**N. Mel Waiters Way 24-inch Water Main Replacement – Phase II**  
**Solicitation Number: CO-00417-SM**  
**Job No.: 21-4001**

**ADDENDUM 2**

**June 1, 2021**

**TRENCH REPAIR (FULL DEPTH) DETAIL**  
 N.T.S.

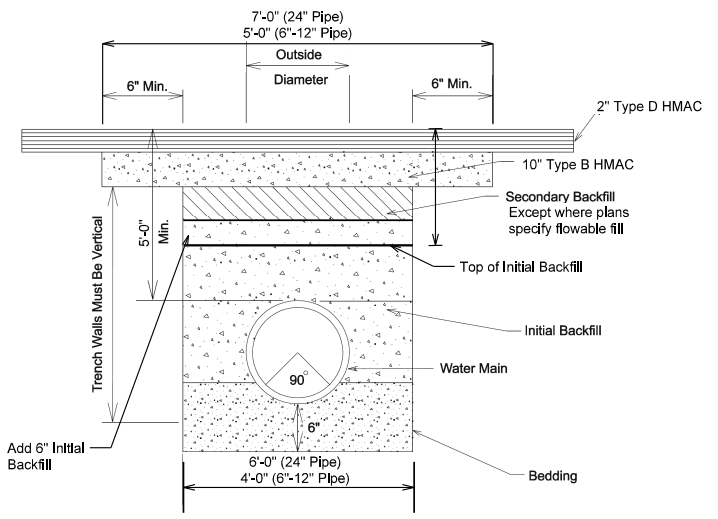
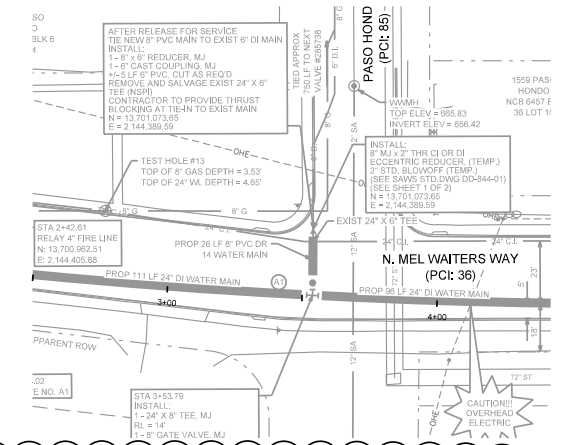
*Response: This contract has been modified to include removal and replacement of existing backfill on the pipeline installed in Phase I. See updates to the Bid Proposal, Special Provisions to Technical Specifications and plans attached to this addendum.*

- a. Added requirement for sequencing for trench restoration for pipeline installed in Phase I.
6. Replace Special Provisions to Technical Specifications (SPTS-1 through SPTS-6) in its entirety with the attached Special Provision to the Technical Specifications (SPTS-1 through SPTS-7). The following items were updated:

- REPAIR TRENCH ON PIPELINE INSTALLED IN PHASE I PER DETAILS SHOWN IN THE PLANS AND LIMITS ON SHEETS 16-20.
  - COORDINATE WITH SAWS TO SHUT DOWN EXISTING 24" MAIN AND 6" MAIN BETWEEN BURNET AND HAYS.

- NOTE:**
- CONTRACTOR TO EXCAVATE EXISTING WATER MAIN TRENCH TO TOP OF INITIAL BACKFILL OR TO TOP OF EXISTING FLOWABLE BACKFILL (IF APPLICABLE). PLACE 6" ADDITIONAL INITIAL BACKFILL AND REPLACE AND RECOMPACT TRENCH. COMPACT MATERIAL AND PERFORM DENSITY TEST PER ITEM 804.

N. MEL WAITERS WAY  
 24-INCH WATER MAIN  
 REPLACEMENT - PHASE II  
 RESTORATION PLAN  
 BEGIN TO STA 8+00

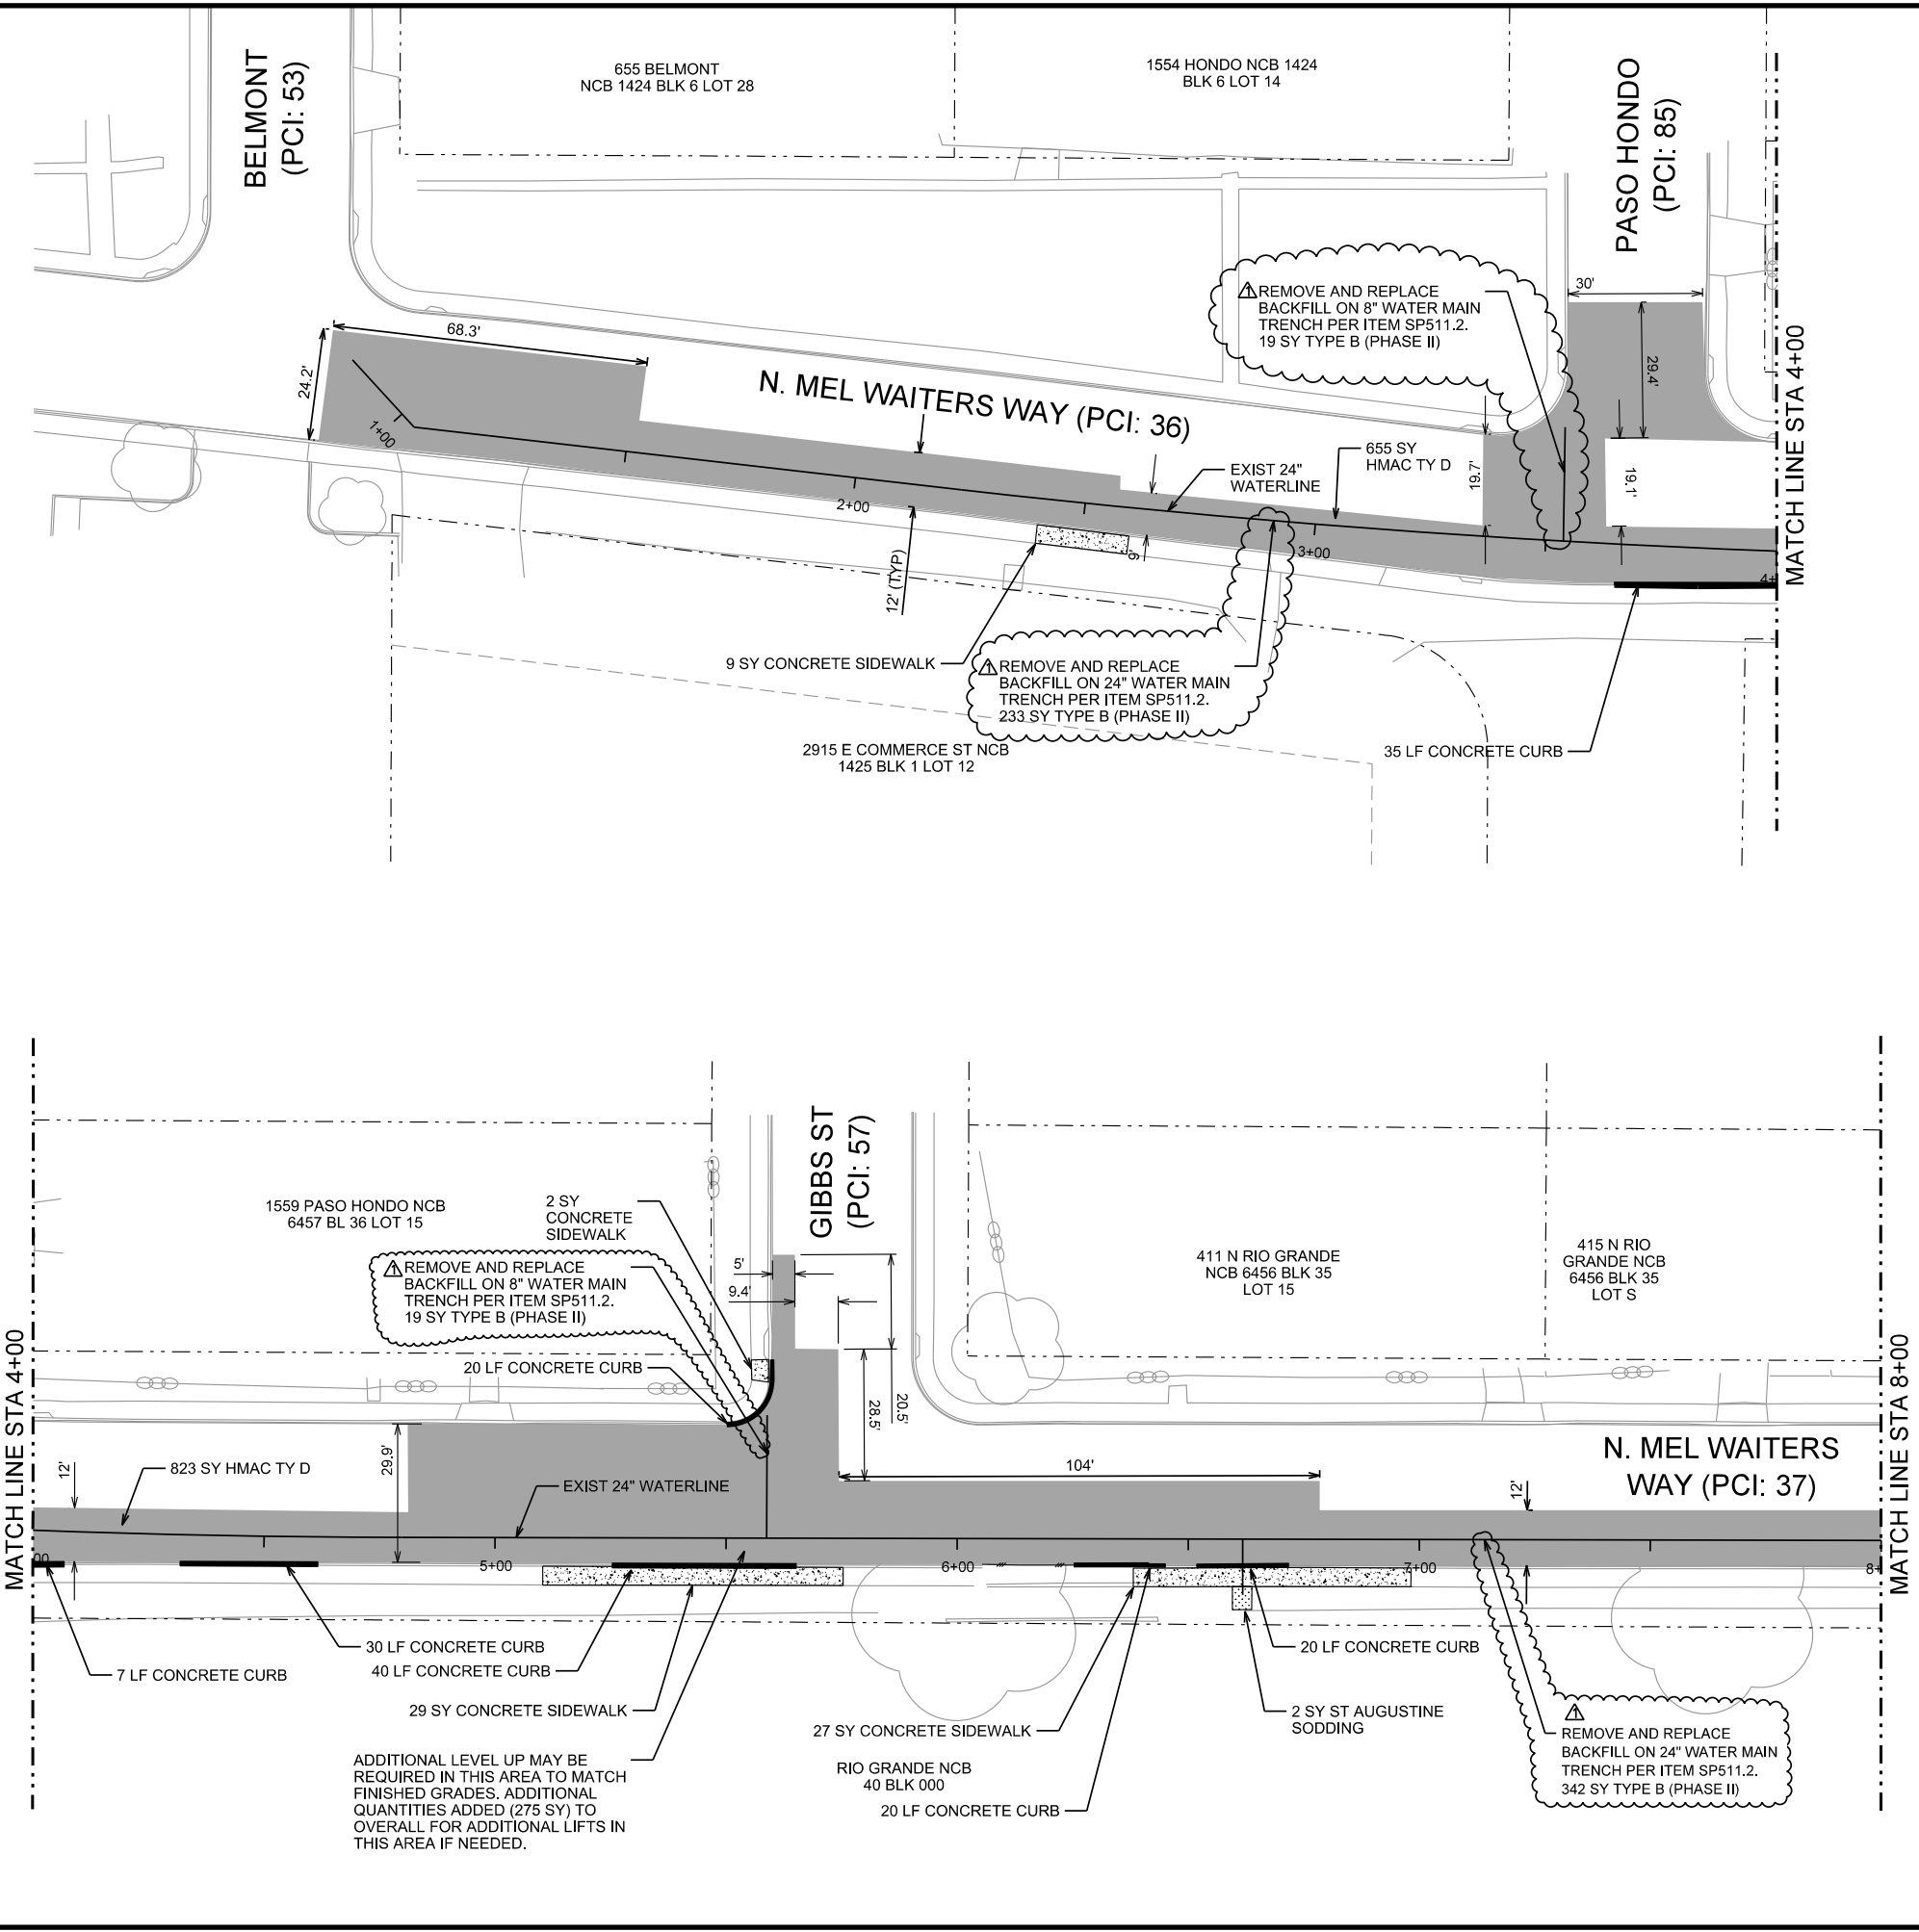
- NOTE:**
- ADDITIONAL RESTORATION ITEMS BEYOND THOSE SHOWN ON SHEETS 16-21 HAVE BEEN ADDED TO THE OVERALL PROJECT QUANTITIES. THESE ADDITIONAL ITEMS SHALL ONLY BE USED IF AUTHORIZED BY SAWS.

**TRENCH REPAIR (FLOWABLE FILL) (APPROX STA 16+00)**  
N.T.S.

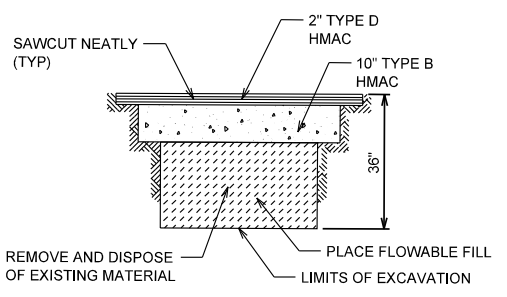
- 8. Previous project phase seems to have Issues with trench collapse at various locations, this will affect the mill and overlay paving. As per Item SP511 and Detail on sht 22, we are to use flowable fill 24IN Thick and 10in of TY B, can we use flowable fill in lieu of the 10in TY B the trench repair as well?**  
*Response: Type B hot mix asphaltic pavement will be required as shown in the detail on sheet 22.*
